DESIGN <b>A</b>	DRAWN BY <b>B</b>	<b>DART AEROSPACE LTD</b> HAWKESBURY, ONTARIO, CANADA	
CHECKED <b>LE</b>	APPROVED <b>A</b>	DRAWING NO. DSI 9273	REV. B SHEET 1 OF 1
DATE 07.05.30		TITLE ADD D350-607-045	SCALE NTS
A	04.02.02	NEW ISSUE	
B	07.05.30	CORRECTED TYPO ON CERT NUMBER

## **DART SERVICE INSTRUCTION**

TO AMEND INSTALLATION DRAWING D350-607 REV. F

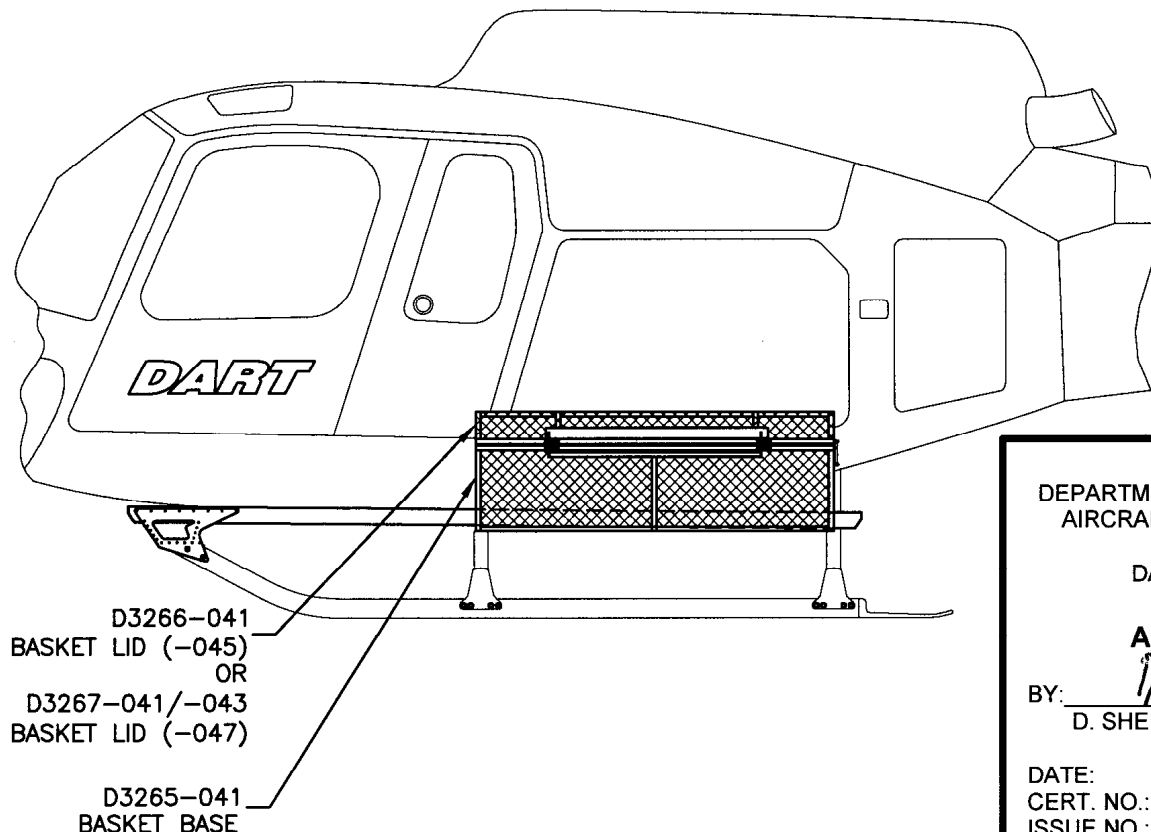
Add D350-607-045 and D350-607-047 to D350-607 Rev.F. Install and maintain D350-607-045/-047 the same as D350-607-041/-043. Parts list for D350-607-045 is same as D350-607-041, except that D3265-041 Base replaces D2221 Base and D3266-041 Lid replaces D2512 Lid. Parts list for the D350-607-047 is the same as D350-607-043 except that D3265-041 Base replaces D2221 Base and D3267-041/-043 Lid replaces D2989-041/-043 Lid. Weight & balance for D350-607-045/-047 is as follows:

Installation	Weight	Lateral		Longitudinal	
		Arm	Moment	Arm	Moment
D350-607-045 <i>Heli-Utility-Basket™</i>	65.0 lb 29.5 kg	±48 in ±1.22 m	±3120 in-lb ±36.0 m-kg	135 in 3.43 m	8775 in-lb 101.2 m-kg
D350-607-047 <i>Heli-Utility-Basket™</i>	65.0 lb 29.5 kg	±48 in ±1.22 m	±3120 in-lb ±36.0 m-kg	135 in 3.43 m	8775 in-lb 101.2 m-kg
